17787

RE: Submission – Public Exhibition of the Draft Camellia Town Centre Master Plan

This submission has been prepared by Ethos Urban on behalf of landowners Tuck Hing Ho Pty Ltd (Tuck Hing Ho), in relation to land at 175 James Ruse Drive, Camellia (the Site). It relates specifically to the proposed *draft Camellia Town Centre Master Plan* (Draft Master Plan) and supporting studies, prepared by the Department of Planning and Environment (DPE).

Figure 3 Proposed floor space ratio

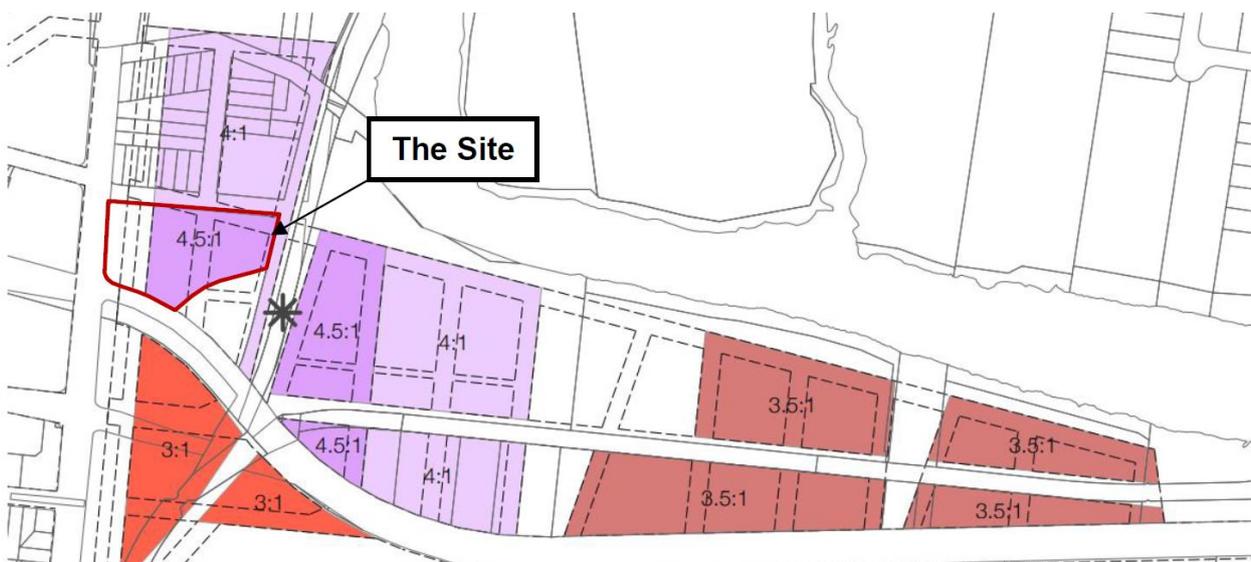
The proposed FSR of 4.5:1 has been applied to the eastern portion of the Site, however does not extend to the full envelope of the urban blocks, with no FSR control applied to this adjoining Sydney Water Pumping Station (refer to **Figure 3**).

The misalignment of the proposed urban blocks and building envelopes with the site boundary and proposed FSR significantly discounts the maximum gross floor area (GFA) that could be generated by the proposed FSR of 4.5:1 on the Site. The loss of potential GFA is lost to accommodate proposed massing on the adjoining parcel (refer to **Figure 4**).

Figure 4 Built form outcome based on proposed controls in Draft Master Plan

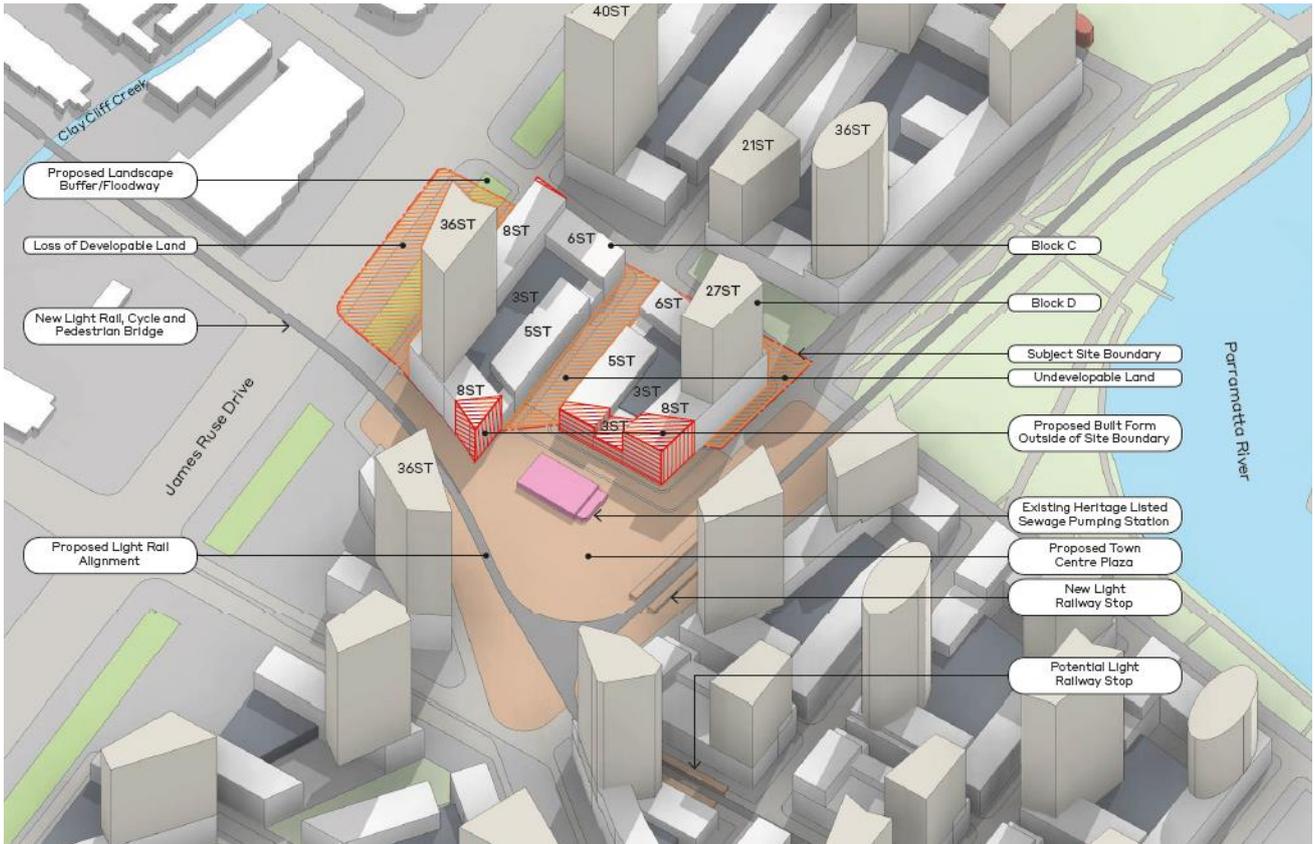
Under this scenario, it was found that approximately 3,259sqm of GFA falls outside the Site's boundary. This resulted in a maximum GFA of 49,419sqm that could be achieved on the site, translating to an equivalent FSR of 3.99:1.

Figure 5 Built form outcome of development within site boundary based on proposed controls in Draft Master Plan

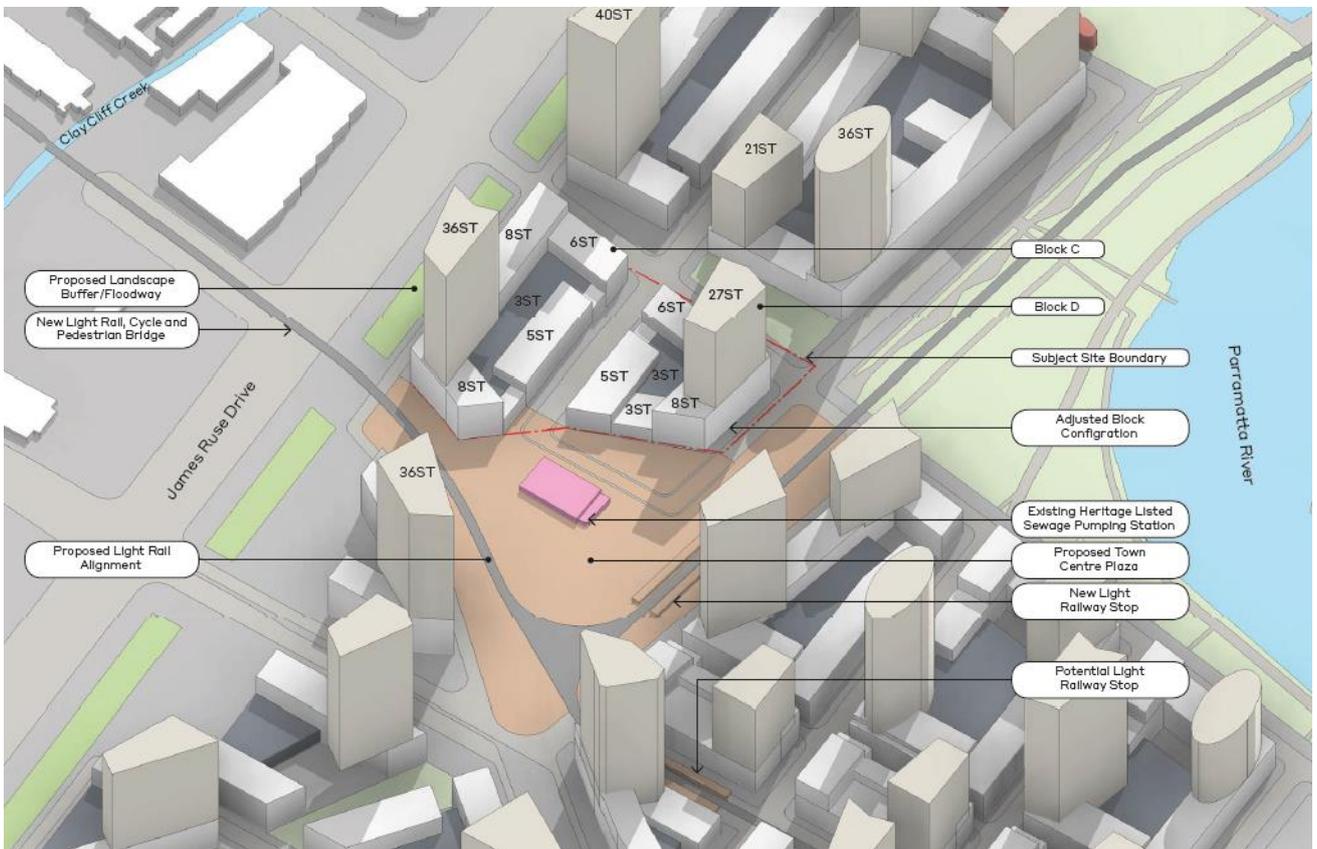
In response to the loss of potential GFA, the urban design analysis investigated the achievable gross floor area (GFA) based on a scenario which contained building mass entirely within the Site (as shown in **Figure 5**). This would allow for development of the Site, independently from the adjoining Sydney Water site.

Building footprints were adjusted to fit within the current land ownership boundary, with proposed envelopes and heights retained from the *Draft Master Plan*. This adjustment maintained building separation and depth and resulted in a maximum GFA of 49,719sqm, translating to an equivalent FSR of 4.02:1.

This scenario presents the most realistic option for future development of the Site based on the proposed planning controls of the *Draft Master Plan*. However, it does not represent the best urban design or planning outcome in that it does not allow for a coordinated design or planning response to the adjacent Sydney Water site, which is identified in the *Draft Master Plan* as a key public plaza and central community space within the Camellia Town Centre, and it does not maximise density or height closest to the future light rail and Town Centre.

Figure 6 Built form outcome based on increased heights within Draft Master Plan

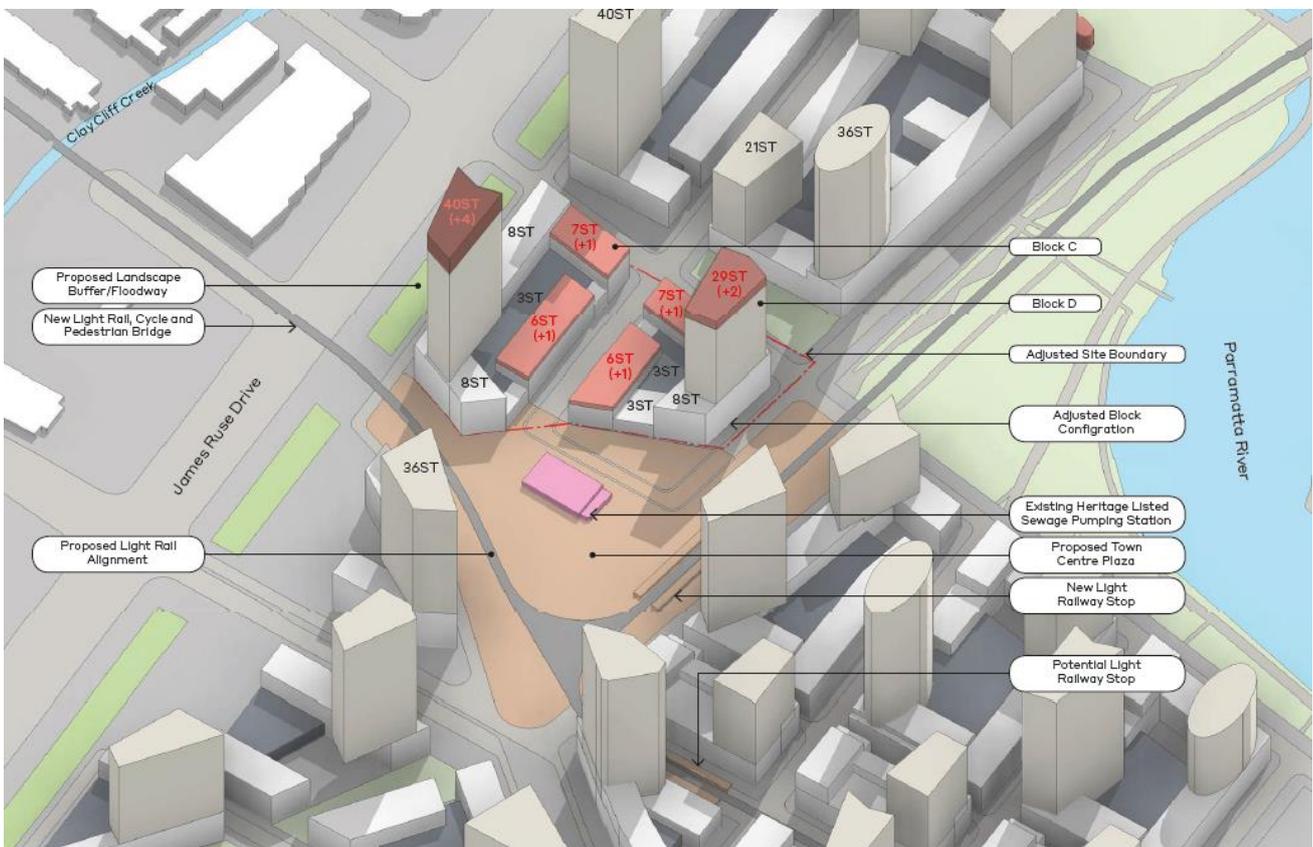
Further analysis was undertaken to establish a built form response to accommodate a GFA equivalent to the proposed 4.5:1 FSR (refer to **Figure 6**). The following changes were proposed:

- reconfigure building envelopes with existing southern boundary alignment;
- increase number of storeys for proposed tower on Block C to 40 storeys;
- increase number of storeys for proposed tower on Block D to 29 storeys; and
- provide an additional storey to the podium setting addressing River Road East and First Street.

The Site is located adjacent to the Camellia Train Station and future light rail stop and is destined to become an important catalyst for the revitalisation and development of the future town centre. This additional required height remains in keeping with the vision for the precinct as well as Camellia’s strategic positioning within the hierarchy of activity centres across Greater Sydney.
